| REF | | QTY | | PART or DRWG No. | | DESCRIPTION | | | | MATERIAL | |
|--|--|-------------|--|--------------------------|--|-----------------|--|----------------|--|--|--|
| TOLERANCES: FRACTIONAL ±1/16 ANGULAR ±.25° TWO PLACE DECIMAL ±.01 | | | THREE PLACE DECIMAL ±.005 FINISHED SURFACE RMS 63 BREAK CORNERS IN .015 (OUT) .015 REMOVE ALL BURRS | | | | | | MIT CALIFORNIA INSTITUTE OF TECHNOLOGY MASSACHUSETTS INSTITUTE OF TECHNOLOGY | | |
| REFERENCE DRAWINGS | | | | | | | | | | CAD FILE: D980558-B SIZE: C DWG. NO.: D980558-B SCALE: 1:1 SHEET: 1 OF 1 | |

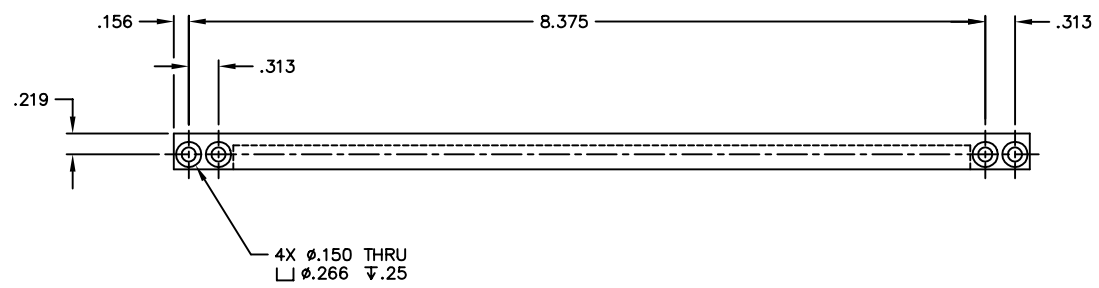
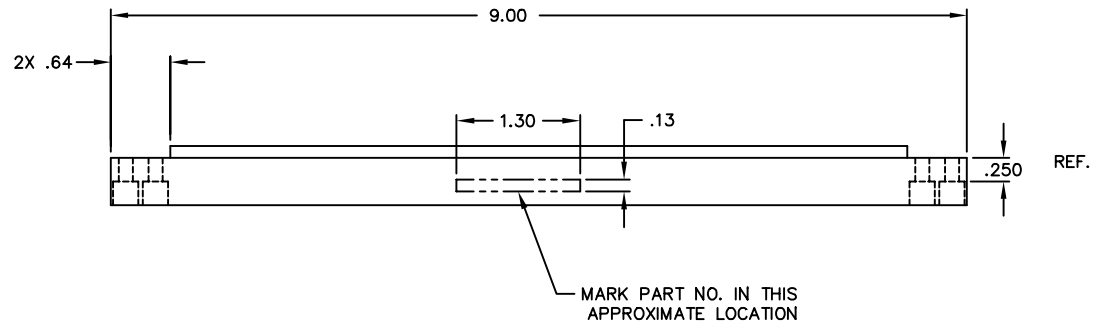
~~Liquid containers or Machining lubricants~~
 Liquids containing hydrocarbons or other contaminants, other than the machining fluids specified herein, shall not be allowed to come into contact with suspension material at any time. All machining fluids shall be water soluble and free of sulfur, chlorine and silicone, such as Cincinnati Milacron's Cimtech 410 (stainless steel).

~~Identification Serial Number~~
 A serial number shall be etched, or scribed on the part see note drawing note.
~~Serial Number format~~
 The Serial number shall be of the format: D99xxxx-x-001
 Example: D990021-A-001
 The drawing number, The revision number, The sequential part number
